MAHONING ROAD NE
 STA-0153-01.70

REVISIONS:
 CONSTRUCTION BIDDING SET
 APPENDIX NO. 1

REVISIONS	DATE	BY
CONSTRUCTION BIDDING SET	4/21/14	GEA
ADDENDUM NO. 1	5/7/14	GEA

ROADWAY GRADING PLAN
STA. 89+50 TO STA. 95+50

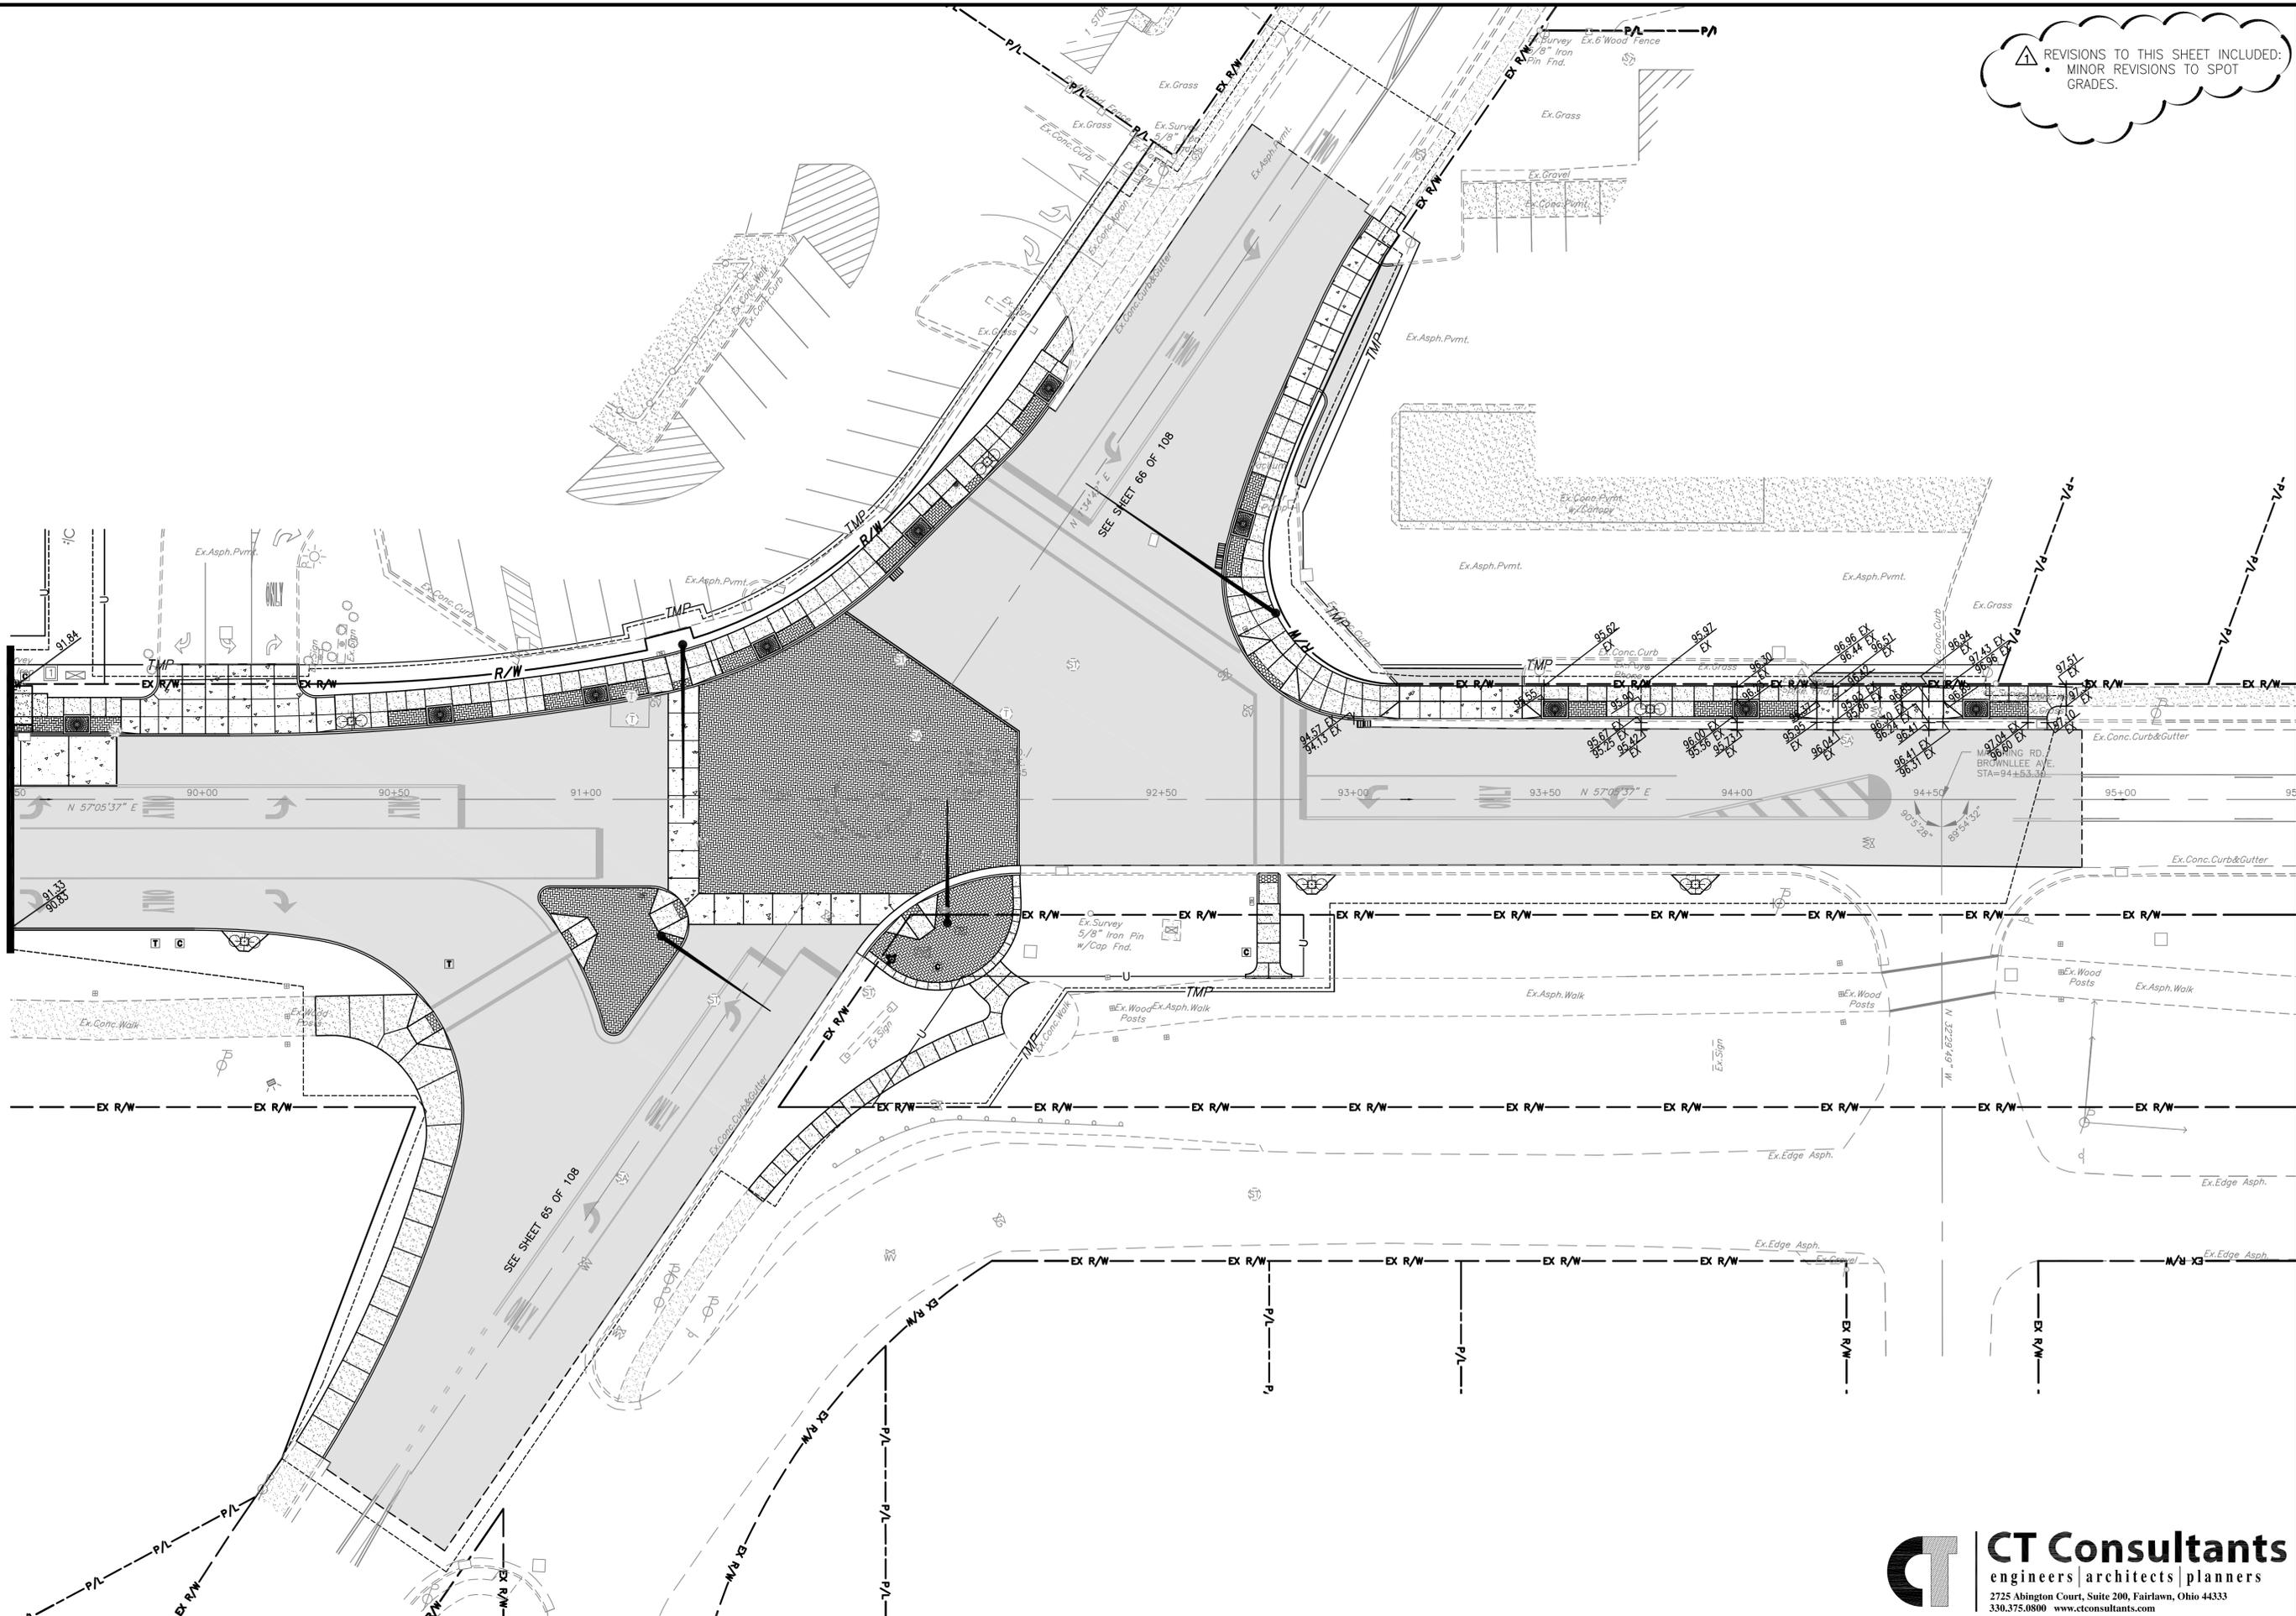
△ REVISIONS TO THIS SHEET INCLUDED:
• MINOR REVISIONS TO SPOT GRADES.
